REGIONAL REVIEW NOTIFICATION

ARC REVIEW CODE: R1804301

Name of Proposal: Campbellton Site (DRI 2791)

CAMPBELLTON LOGISTICS CENTER DRI
Fulton County
ARC Natural Resources Group Comments
April 26, 2018

TITLE: DRI # 2791 SITE PLAN

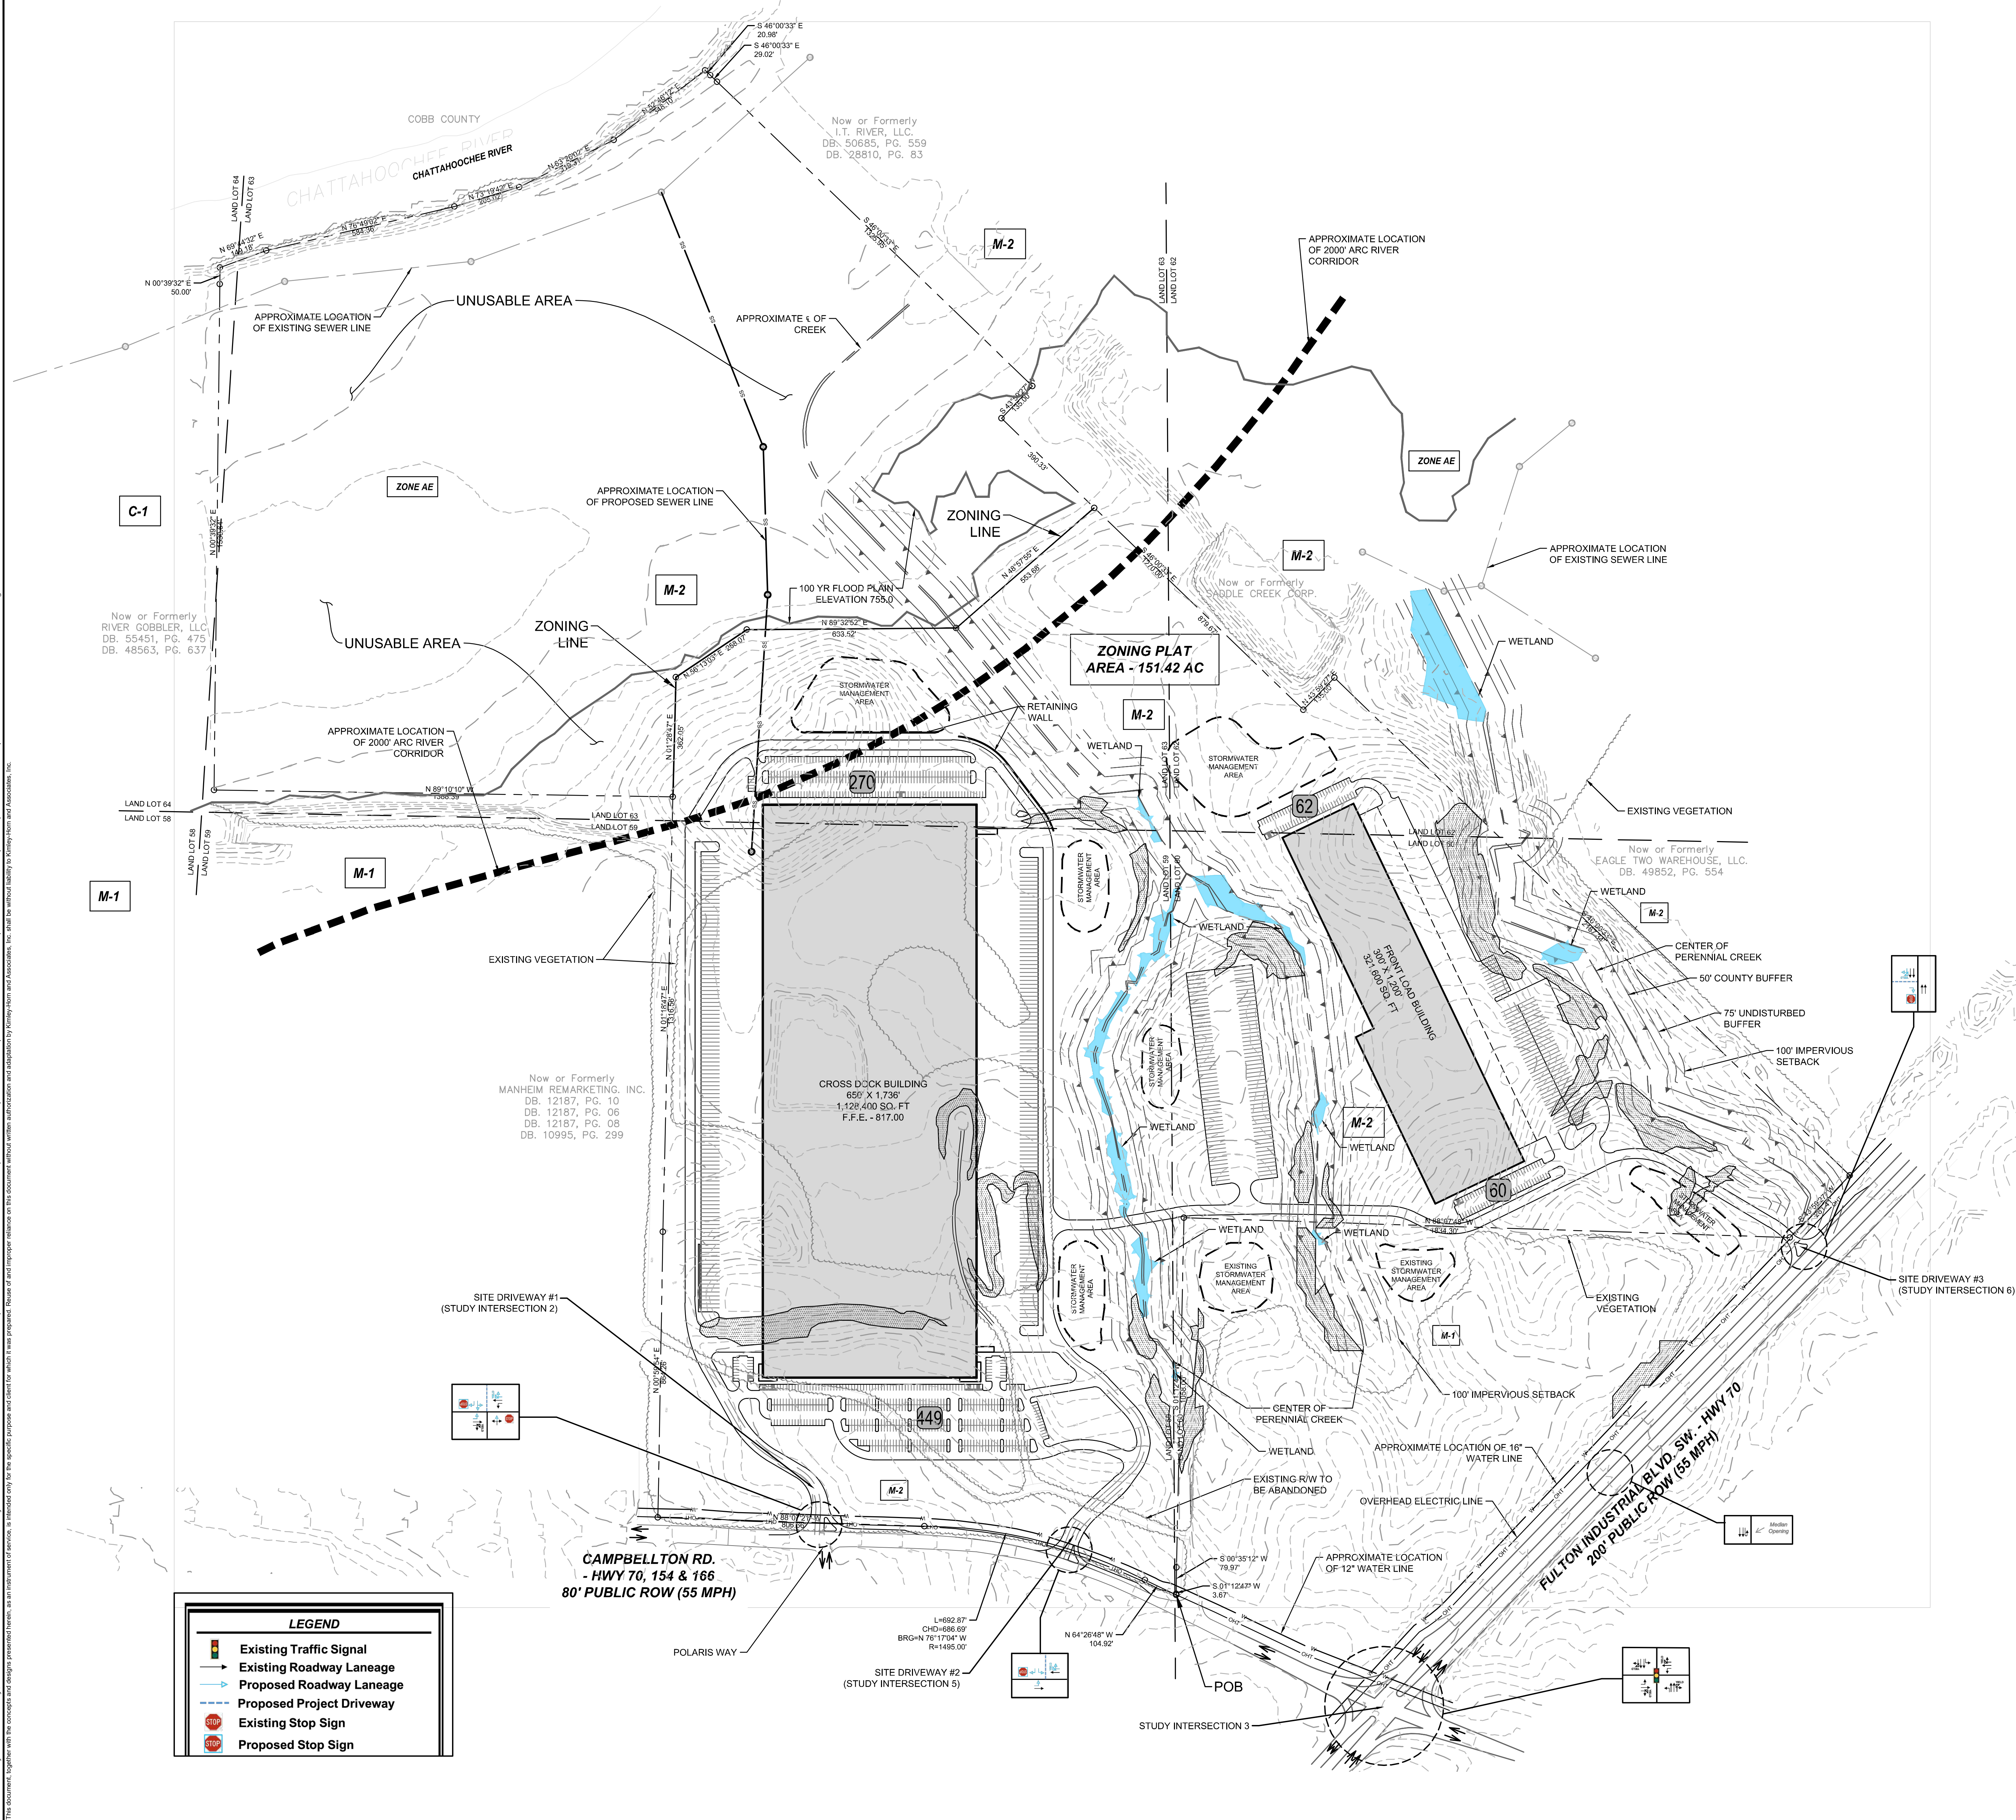
- ☐ YES (connections to adjacent parcels are planned as part of the development)
- ☐ YES (stub outs will make future connections possible when adjacent parcels redevelop)
- ☒ NO (the site plan precludes future connections with adjacent parcels when they redevelop)
- ☐ OTHER (Please explain)

Bicycle and pedestrian facilities do not currently exist along roadways adjacent to the development site. Sidewalks and bicycles facilities are proposed as a part of the development.

All site access points allow for the both vehicle and freight access.

A sidewalk currently exists along the west side of SR 70 and ends on SR 154/92, west of its intersection with SR 70. This sidewalk should be extended/developed along SR 154/92 adjacent to the site.
